JACK CANDELARIA COMMUNITY CENTER ADDITION

400 SAN JOSE AVE, SE
ALBUQUERQUE, NEW MEXICO 87102
100% CONSTRUCTION DOCUMENTS
OCTOBER 13, 2023

SITE PLAN

A001

A6 SITE PLAN
1" = 10'-0"

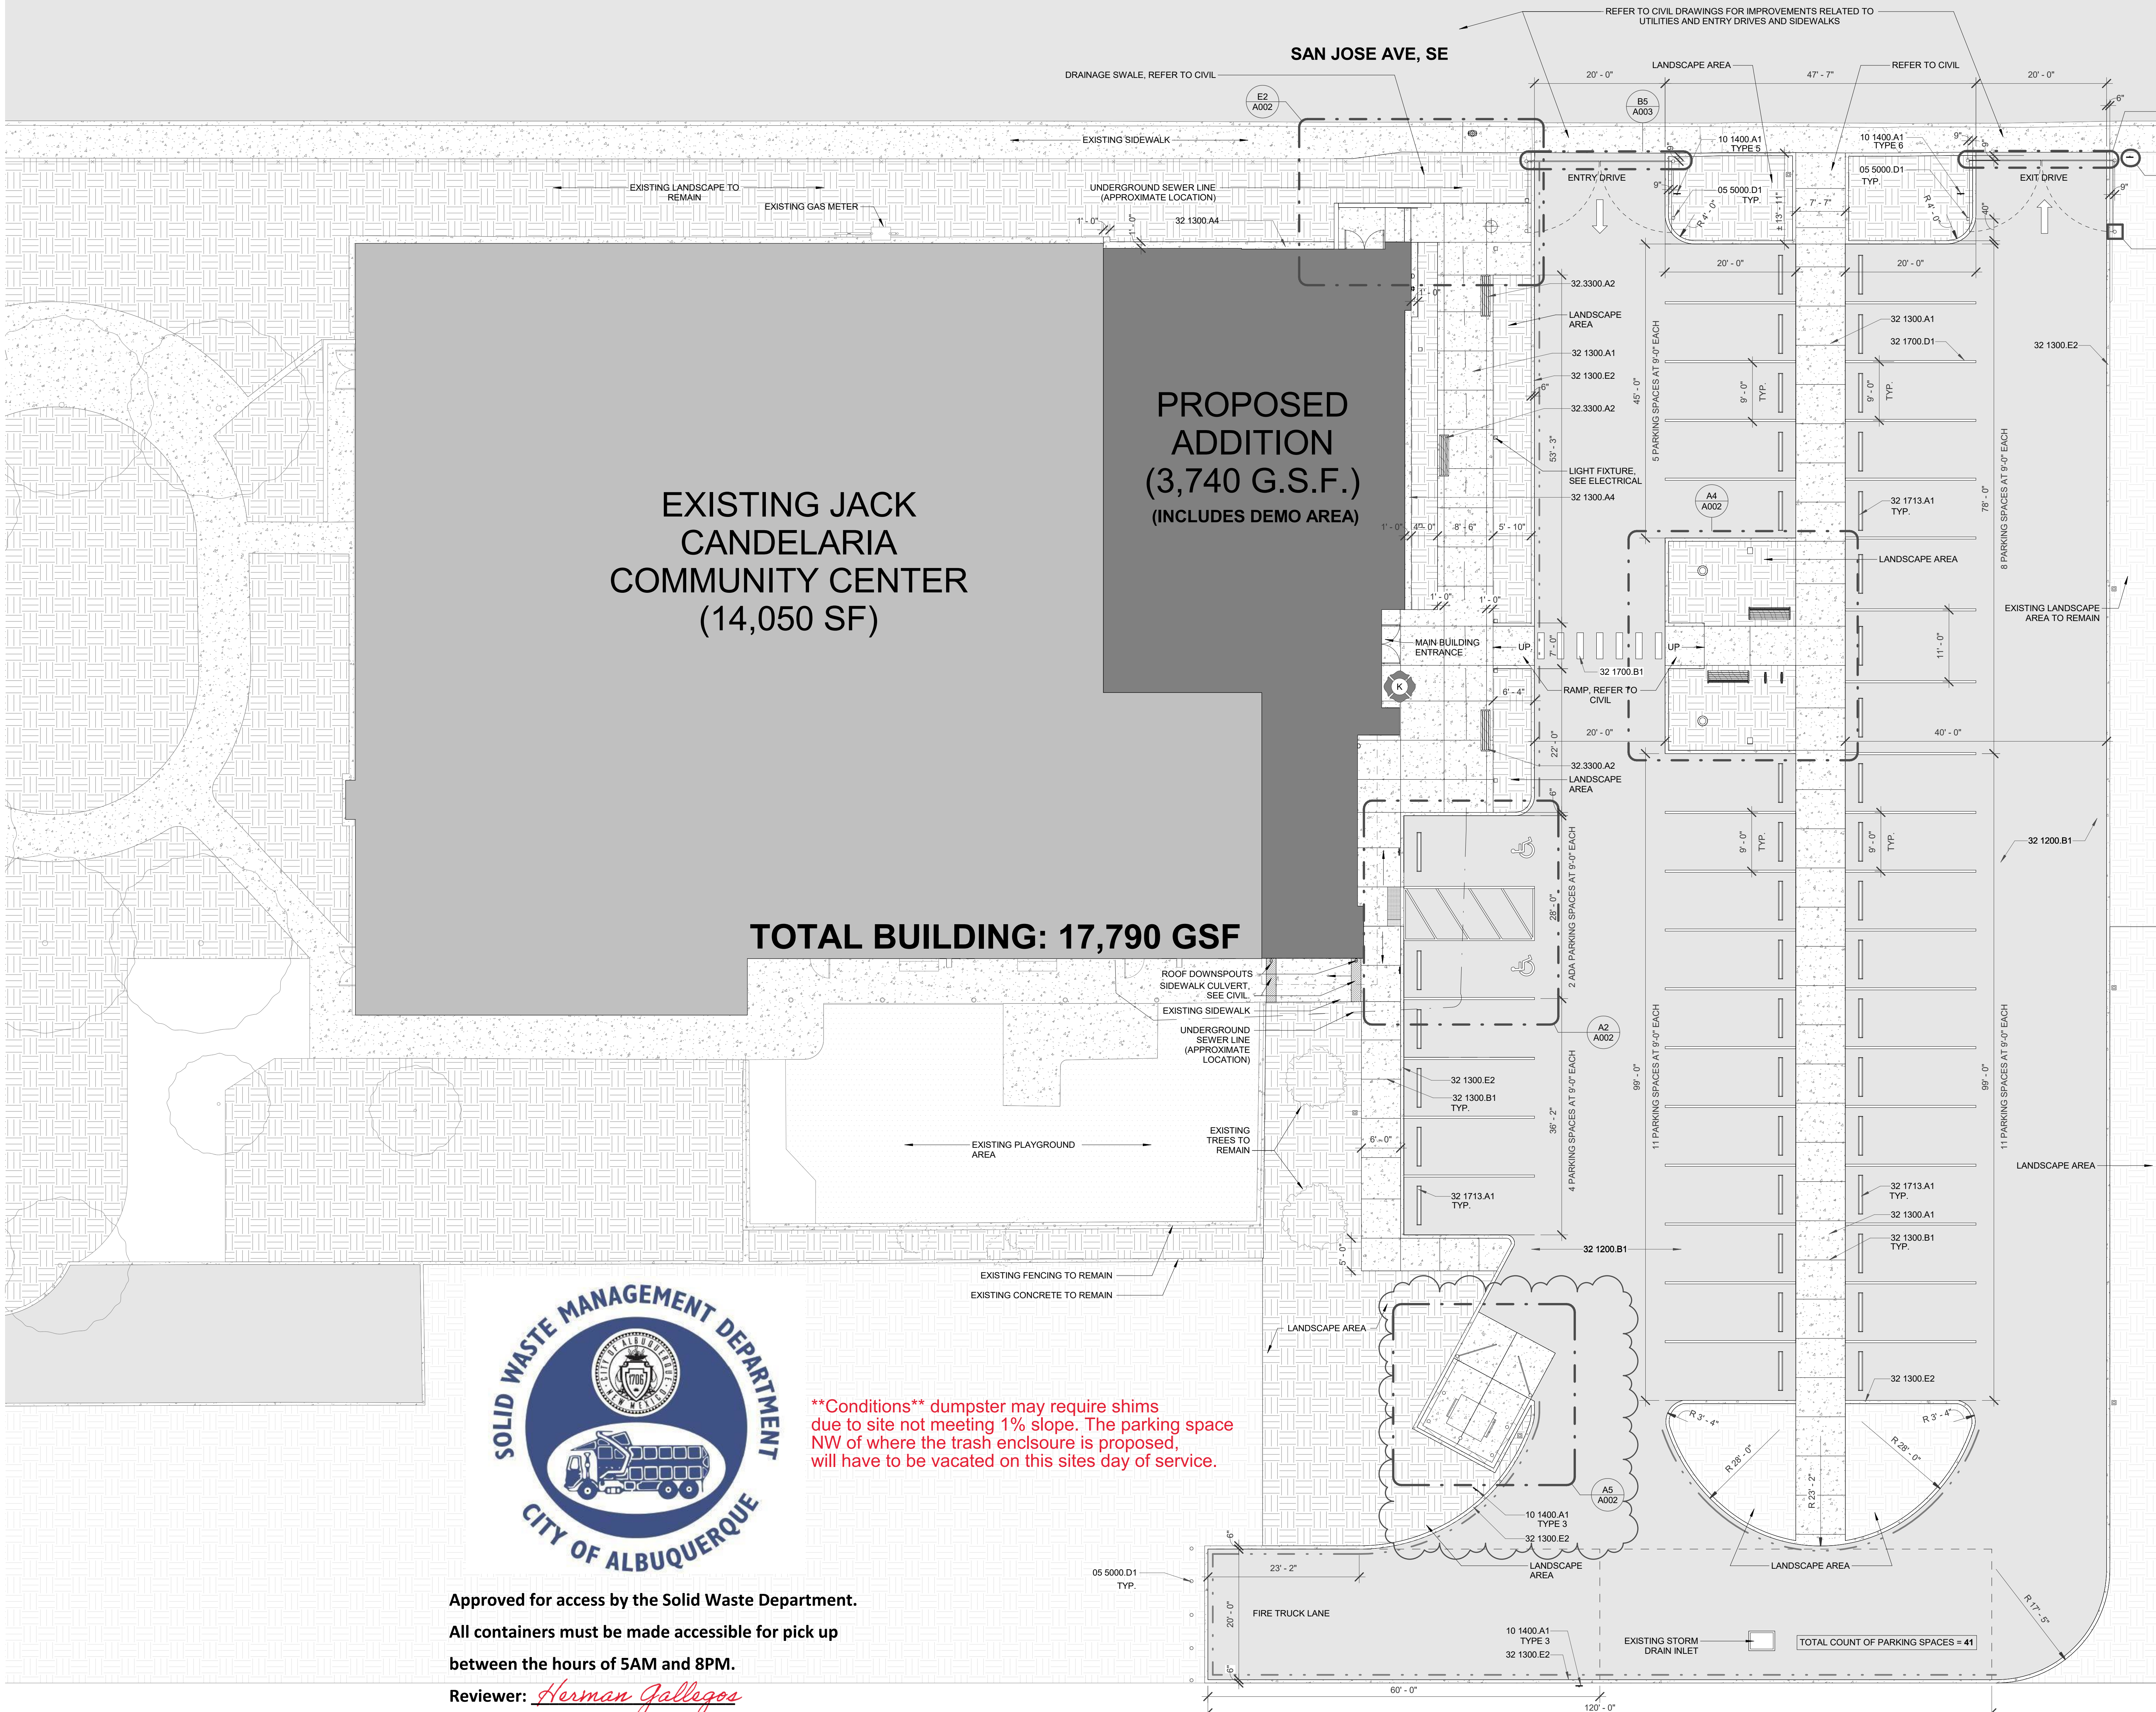
****Conditions**** dumpster may require shims due to site not meeting 1% slope. The parking space NW of where the trash enclosure is proposed, will have to be vacated on this sites day of service.

Approved for access by the Solid Waste Department.

All containers must be made accessible for pick up between the hours of 5AM and 8PM.
